BORDE HILL STABLES

DISCHARGE OF PLANNING CONDITIONS 3 & 4 – DM/23/3210

ISSUE 01 – DECEMBER 2024

Extract from approved drawing 241720-PUR-02-00-DR-A-2103 with the area of roof highlighted in magenta.

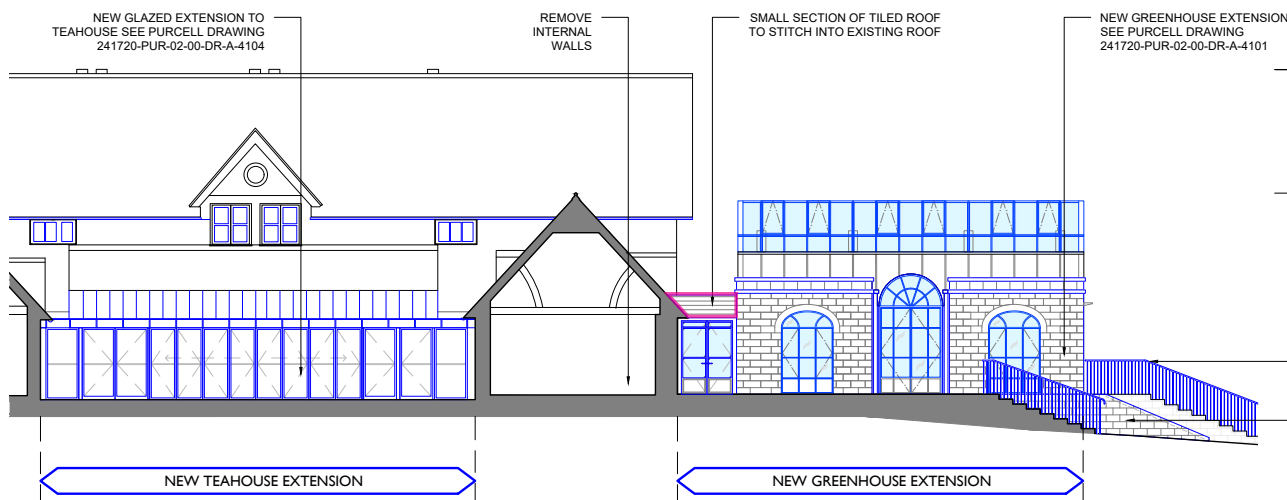
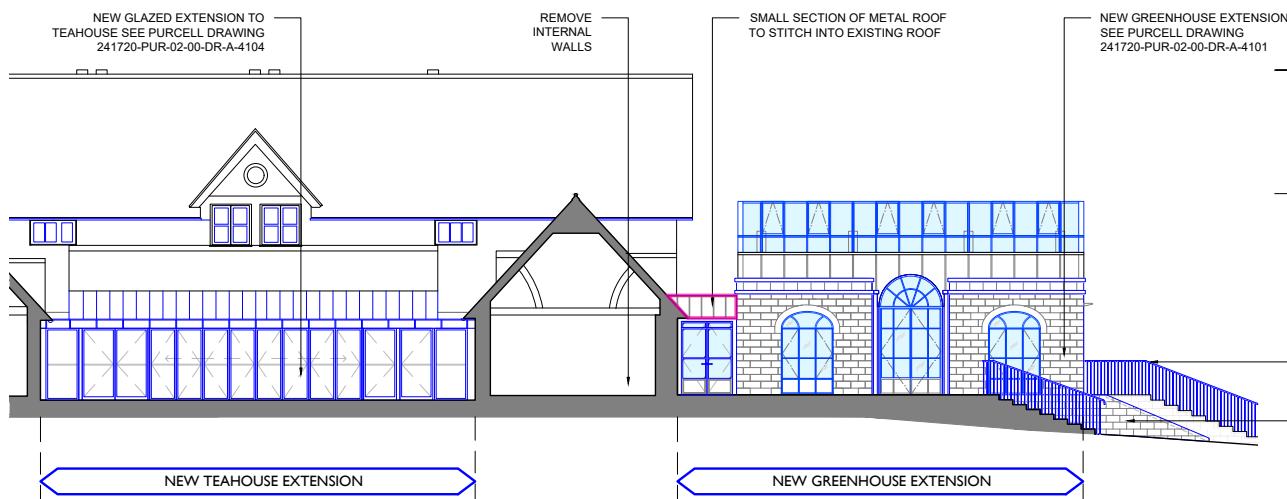
During the design process, the design team have proposed an alternative material for the small area of pitched roof over the link between the glasshouse extension and existing stable building from clay tiles to a standing seam metal roof.

This minor difference in materiality sits over the primary entrance to the restaurant, and has therefore been proposed to differentiate the new glasshouse from the existing fabric of the stable block, clearly defining the new extension in a single design language.

The form and mass remains unchanged, respecting the existing eaves and gutter of the former stable block and thus remaining subservient to the host building.
